4006-1, 4051/52/52A DISPLAY BOARD MOD

Corporate Mod #54922

Figure 1

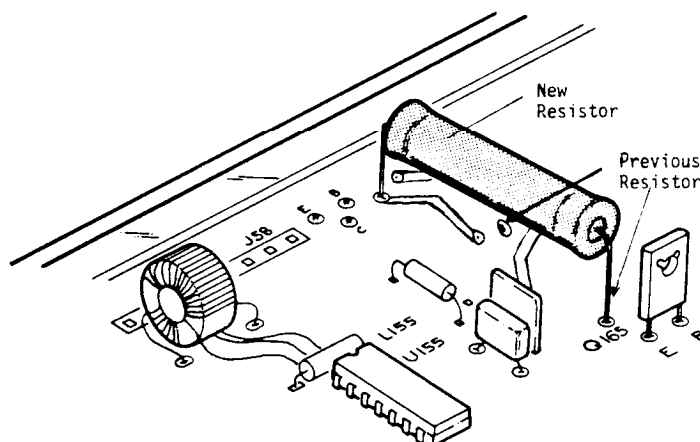
The display board in the 4006-1, 4051/52/52A products is experiencing a high failure rate due to high AC line voltages causing the failure of R64, R339, and Q165. The failure of R64 can generate enough heat to scorch, or even burn, the board.

Corporate modification #54922 fixes this failure mode by changing the value, wattage and placement of R64, and changing the source voltage of the CE1/CE2 circuit from +320 volts to +185 volts. To accomplish this, R64 is physically repositioned. It now connects between the +185-volt source (R39) and the collector of Q165. Physically, it will be positioned as shown in Figure 1.

R64 changes from 68K 2W resistor, P/N 305-0683-00, to a 30K 8W resistor, P/N 308-0105-00. The Display board for the 4006-1 changes from a 672-0537-11 to a 672-0537-12 and the Display board for the 4051/52/52A changes from a 672-0546-11 to a 672-0546-12.
